CITY OF ALBUQUERQUE

RE: Lot 22 Block 6 Volcano Cliffs Unit 22 SAD 227 8009 Camino Alto Grading and Drainage Plan Engineers Stamp Date 6/7/2022 (E10D077) Pad Certification Date None

GRADING AND DRAINAGE PLAN

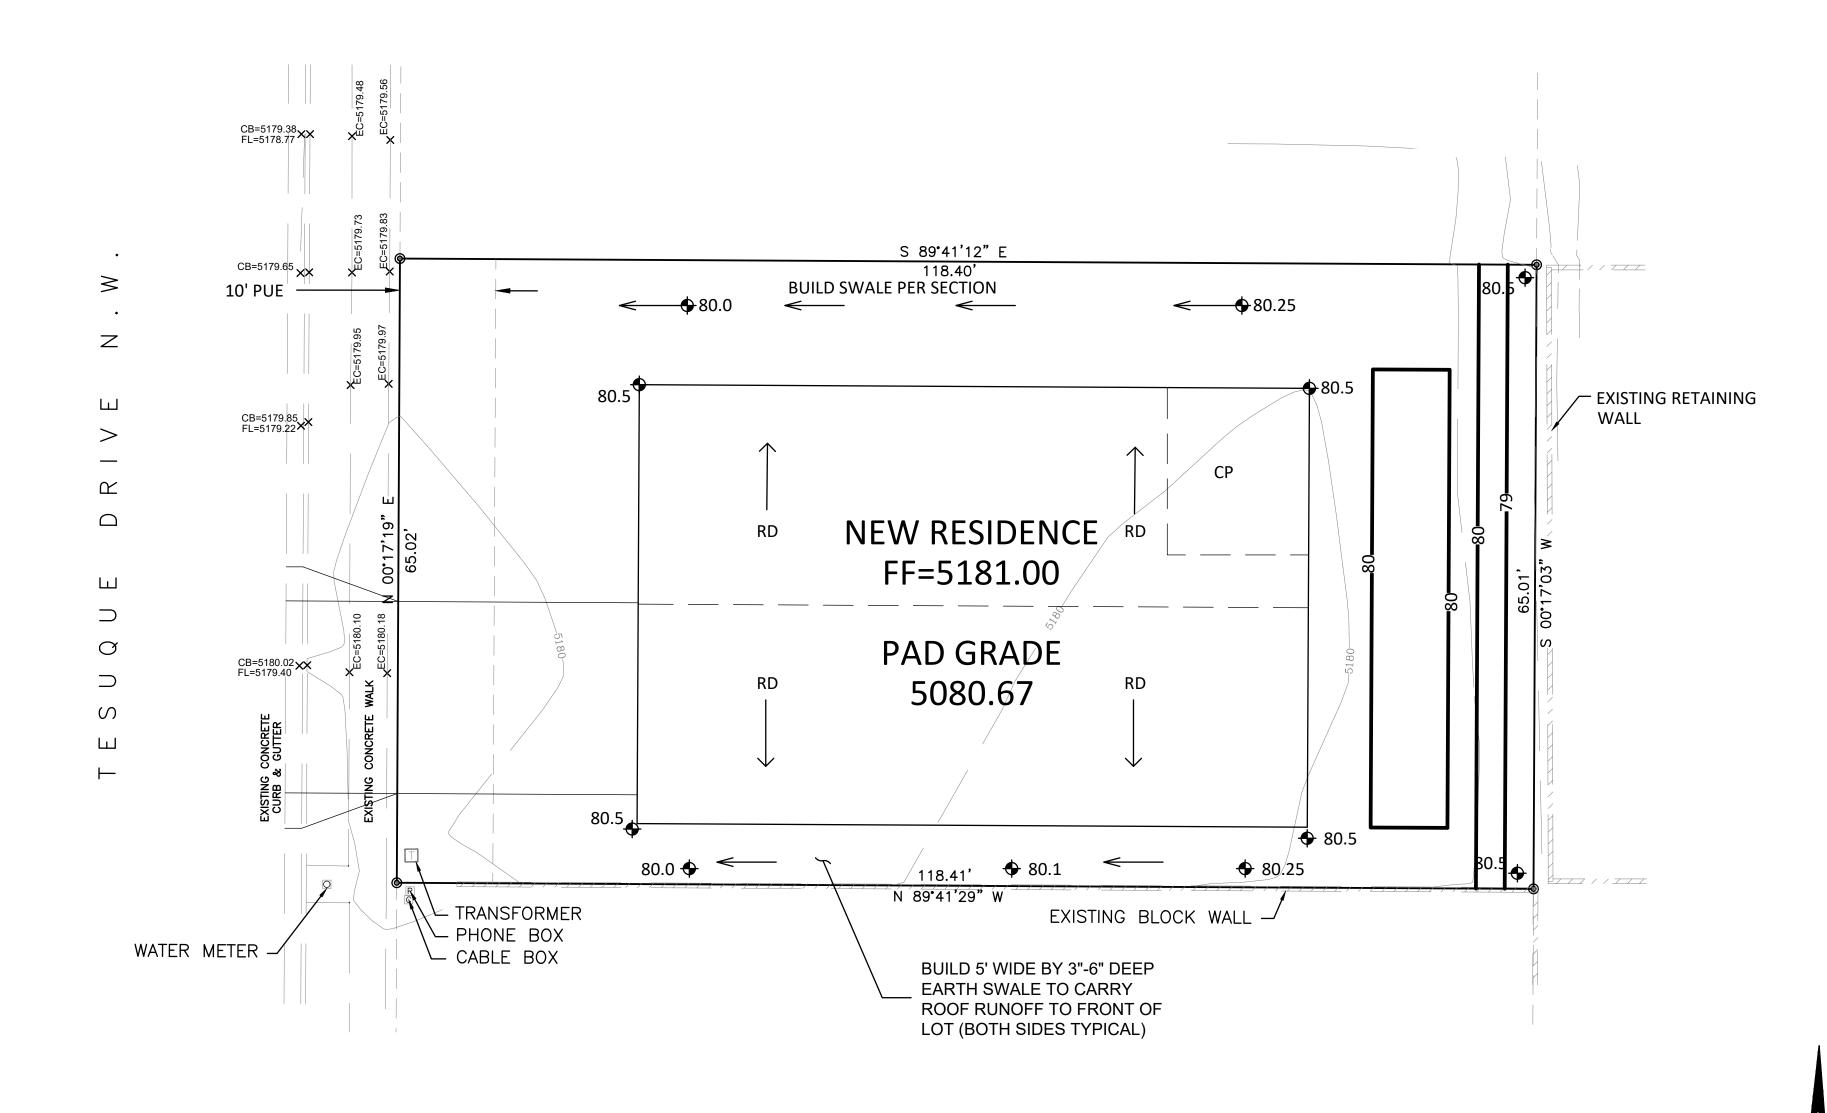
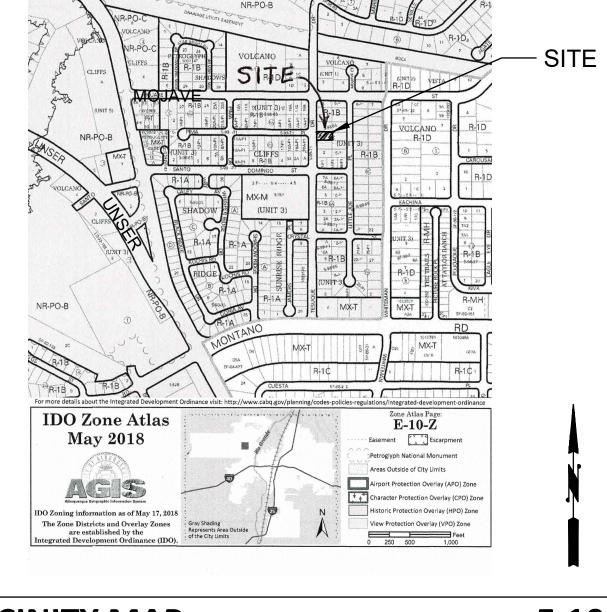
- Provide a table with land treatments, those that are allowed and those which are applied to this plan. This is in SAD 227; these land treatments should be followed.
- Inform Owner/Contractor not to use dirt as a ramp to climb curbing or drive over the sidewalk. Only crusher fines or lumber may be used for this process.

- Provide ponds in the front yard for filtration of water before water exits onto public right of way.
- Provide the SFHA map for this area.
- Provide the Pad Certification language.
- Provide the Fad Certification language.
 Provide a note that the swales are to be filled with gravel of some sort.
